HIGH POINT WEST

APPLICATION NUMBER 19 DATE April 7, 2005
APPLICANT High Point West Subdivision
REQUEST Subdivision

DETAIL SITE PLAN

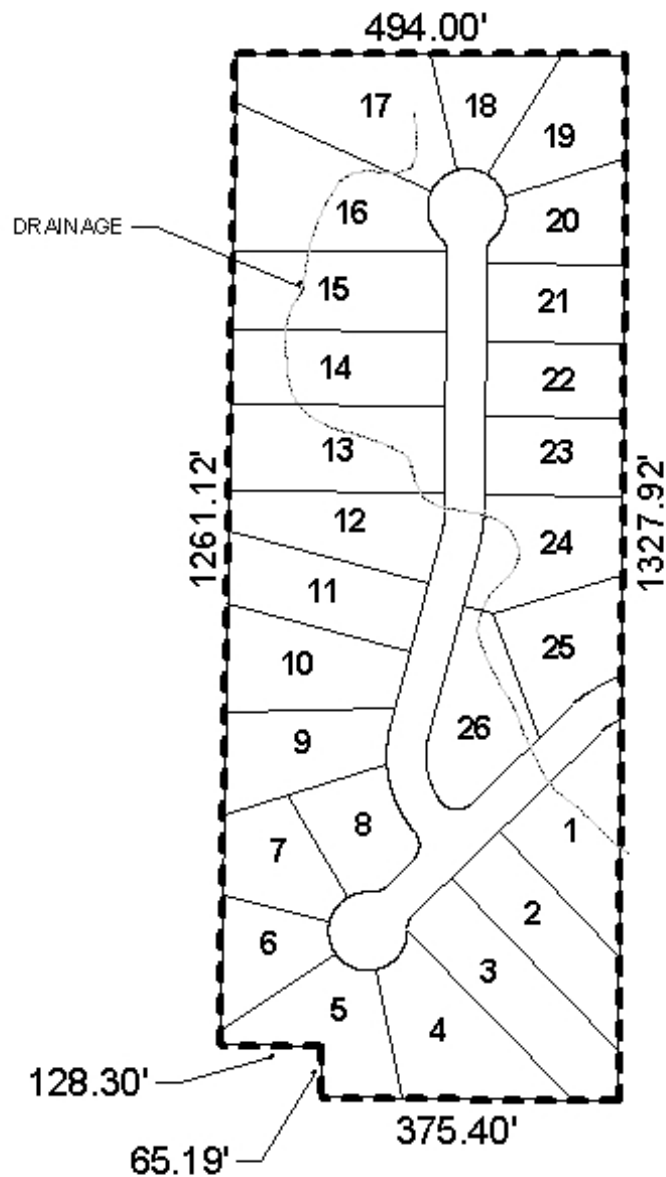
The proposed subdivision includes two cul-de-sacs. The longer of the two cul-de-sacs appears to be approximately 820 feet long, which exceeds the recommended length of 600 feet specified in Section V.D.6. of the Subdivision Regulations. As the land around the site is already developed,

The 25-foot minimum building setback line from the right-of-way edge is not shown (though it is noted on the plat) but would be required on the Final Plat, if approved.

It should be noted that the site has areas of steep topography. These areas are generally located along the eastern and western edges of the site, and in some cases the steep slopes appear to reach a 1 to 1 ratio – 1 foot rise for every 1 foot of distance. The design of the subdivision appears to provide enough area on each lot to allow the construction of a single-family home, while avoiding the steepest topography.

As mentioned in the Engineering Department's comments, no stormwater detention basin is indicated on the subdivision site plan. A stormwater detention basin, sized to meet the requirements of the City's Storm Water Drainage Ordinance, must be indicated on the final plat. Additionally, a note should be placed on the final plat stating that maintenance of the detention basin common area is the responsibility of the subdivision's property owners.

With a waiver of Section V.B.1. for the existing substandard street stub on the west side of the site, and a waiver of Section V.D.6. for cul-de-sac length, the plat is recommended for Tentative Approval subject to the following conditions: 1) the depiction of the 25-foot minimum building setback line on the Final Plat; 2) compliance with all applicable federal, state and local regulations regarding the wetlands and floodplain issues; 3) full compliance with the Engineering comments (*Although this property does not lie within a floodzone it is a SIGNIFICANT drainage area for the surrounding watershed. Storm water runoff from Thigpen Drive, Japonica Lane, Highpoint Drive West, and Trenton Lane all drain through this site. Therefore, the drainage system will have to be designed to accommodate all existing flows onto the property. In addition, increased or concentrated storm water cannot be discharged onto an adjacent property owner without a hold harmless agreement, which appears to be necessary for this site, and there is no common area for stormwater detention shown on the preliminary plat,*

which will be necessary. Must comply with all stormwater and flood control ordinances. Any work performed in the right-of-way will require a right-of-way permit.); and 4) placement of a note on the final plat stating that the maintenance of the detention basin common area is the responsibility of the subdivision's property owners.
